Access Compliance Report

Public Rights-of-Way

(Curb Ramps)

Intersection ID: 4842	Main Street: FARLOW_RD	Cross Street: LOWEN_RD	Location: NW
ADA ID: 707EC5552C5C	Ramp Type: Perp	Initial Pass/Fail: Fail	Overall Compliance: No
		Severity Score: 55

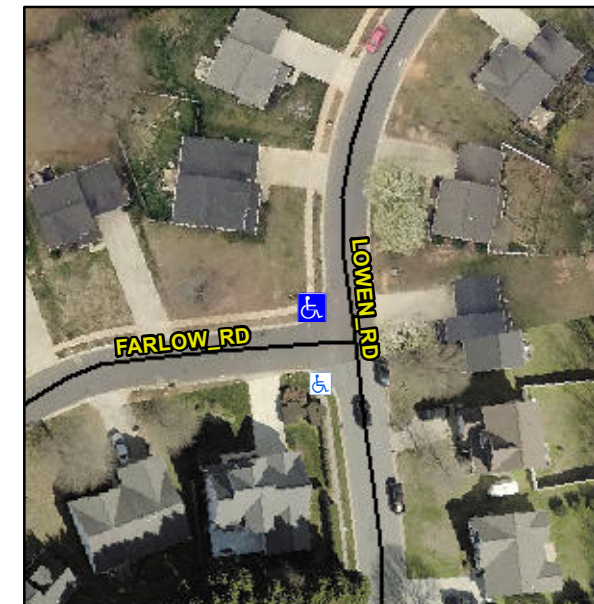
Not Found, R304.5.1, R304.2.2, R304.5.3

Compliance	Description	Data	Compliance	Description	Data
N/A	Ramp Length (in)	49.0	No	Ramp Slope (%)	8.9
No	Ramp Width (in)	35.0	No	Ramp XSlope (%)	8.8
N/A	Flare Type LT	N/A	N/A	Flare Type RT	N/A
N/A	Flare Slope LT (%)	N/A	N/A	Flare Slope RT (%)	N/A
N/A	Flare Traversable LT?	N/A	N/A	Flare Traversable RT?	N/A
N/A	Landing Length (in)	N/A	N/A	DWS Provided?	N/A
N/A	Landing Width (in)	N/A	N/A	DWS Contrast?	N/A
N/A	Landing Slope (%)	N/A	N/A	DWS Length (in)	N/A
N/A	Landing X Slope (%)	N/A	N/A	DWS Full Width?	N/A
N/A	Landing Curb? (Y/N)	N/A	N/A	DWS Offset (in)	N/A
N/A	Shared Landing?	N/A			
N/A	Gutter Ponding?	N/A	N/A	Gutter Slope (%)	N/A
N/A	Gutter Lip Ht (in)	N/A	N/A	Gutter X Slope (%)	N/A
N/A	Painted X Walk1?	No	N/A	Painted X Walk2?	N/A
	X Walk 1 Direction	To S		X Walk 2 Direction	N/A
N/A	X Walk 1 Width (in)	N/A	N/A	X Walk 2 Width (in)	N/A
	X Walk 1 Slope (%)	0.9		X Walk 2 Slope (%)	N/A
	X Walk 1 X Slope (%)	7.5		X Walk 2 X Slope (%)	N/A

Remove & Replace Entire Ramp.
